11 - 2010
FD02 / FD02Z
12V 3/8" DRIVER DRILL KIT

SERVICE CHANGES

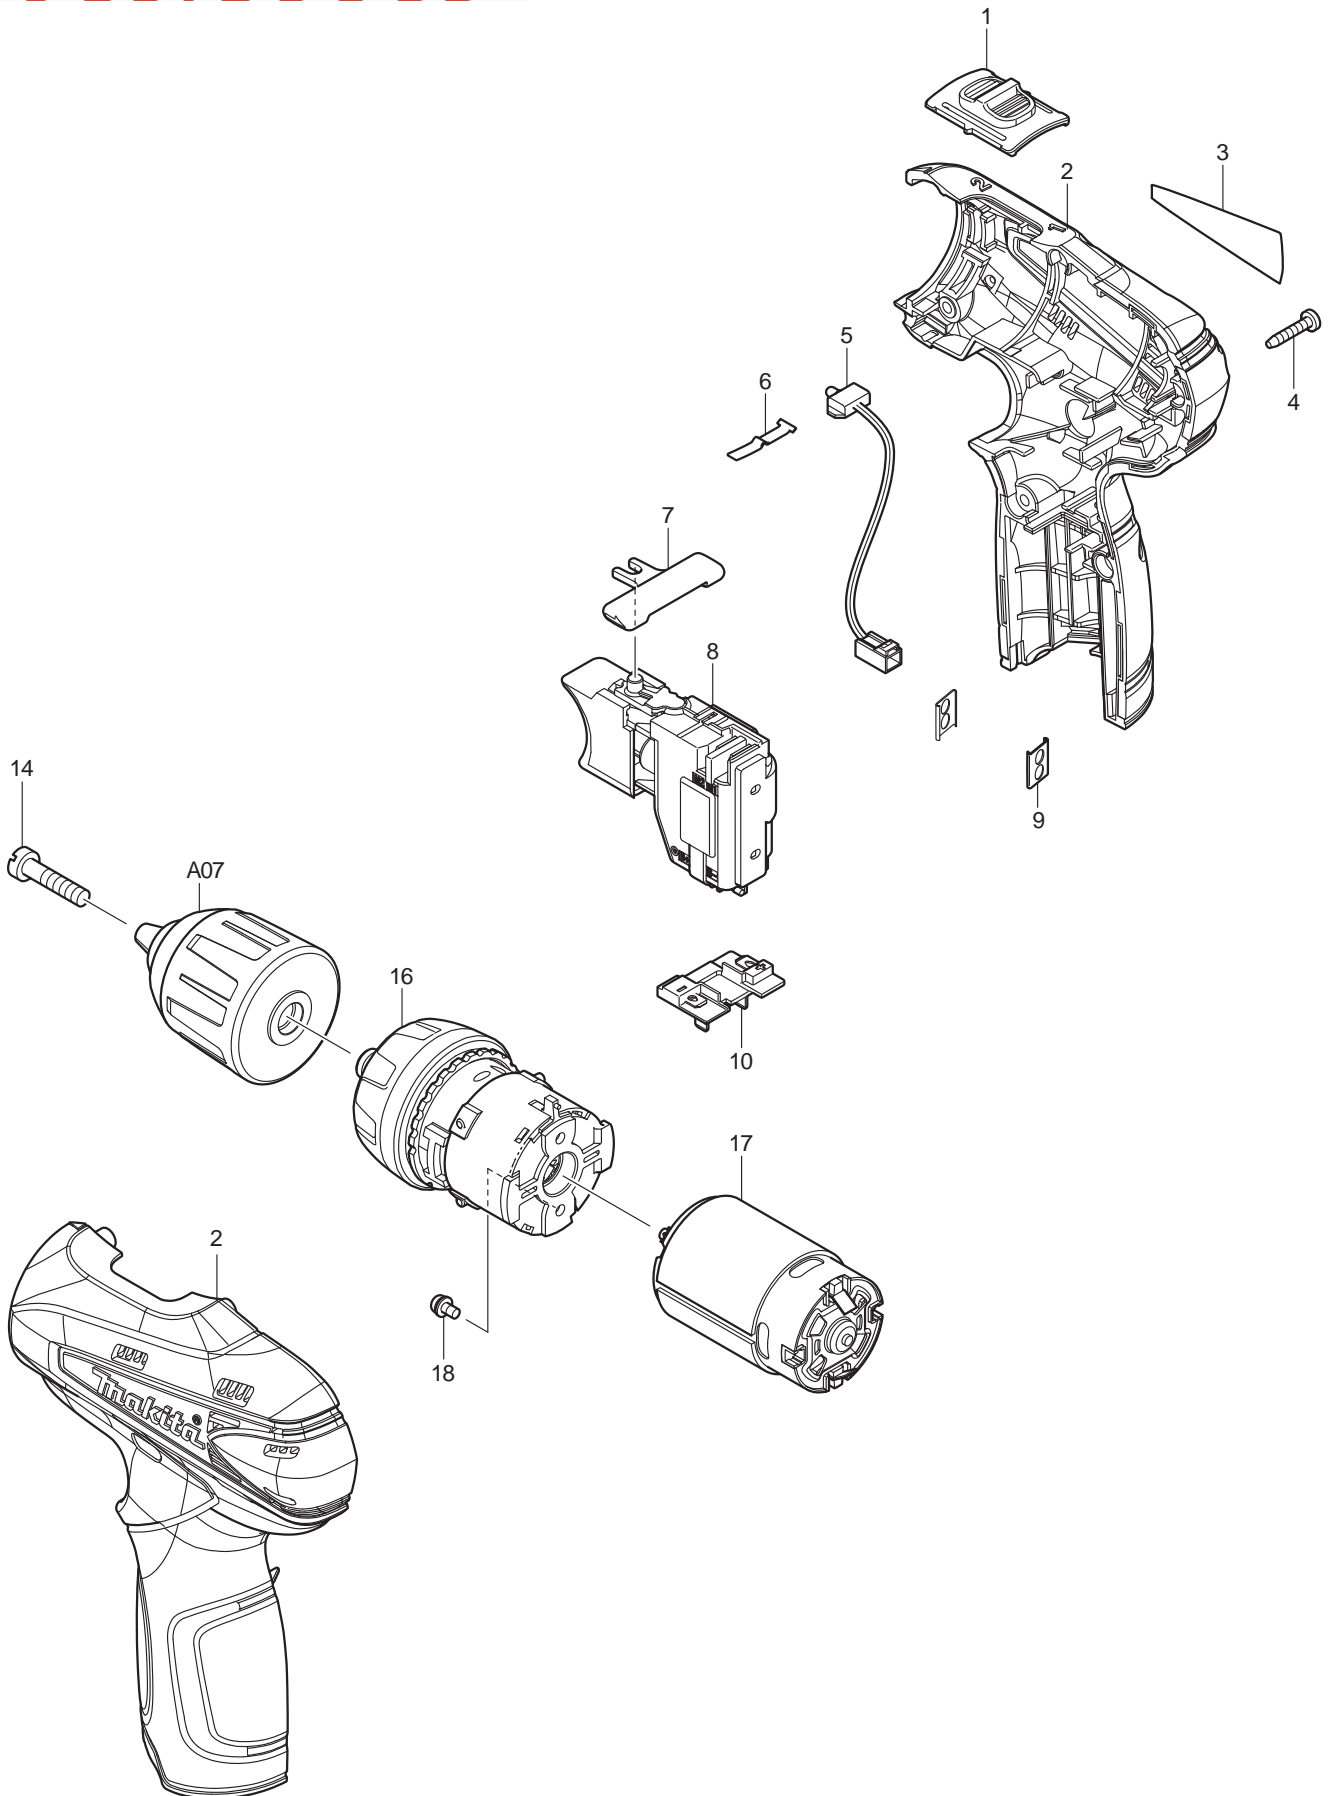
1. Changes on Switch

Item No.	Description	Type 1	Type 2	Type 3
5	LED CIRCUIT	631813-4		-----
8	SWITCH	650599-1	650645-0	650699-7 (W/Battery Protection)

Above parts are completely interchangeable as a set.

For the model manufactured on or after October 2012 using the switch with the number 6506997, be sure to use the Type 3 switch (650699-7) to repair the tool.

For the model manufactured before October 2012 using the switch with the number 6506450, be sure to use the current switch (650645-0) to repair the tool.

2. Changes on Housing Set

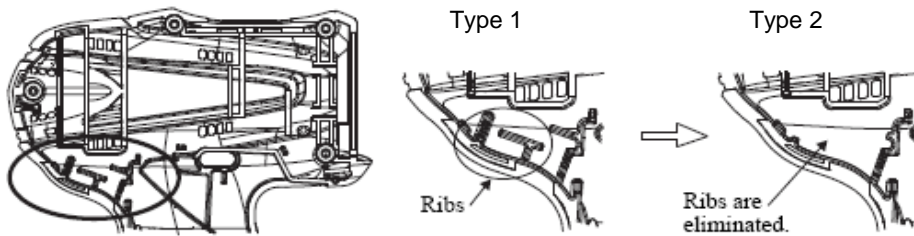
Item No.	Description	Type 1	Type 2	Type 3
2	Housing Set	188498-2	187147-8	187359-3

For the models manufactured with Type1 (before May 2011), use Type 1 Housing set to fix Connector to the inside of ribs. For the models manufactured with Type2 or Type3 (after May 2011), use Type 2 or Type 3 Housing set.
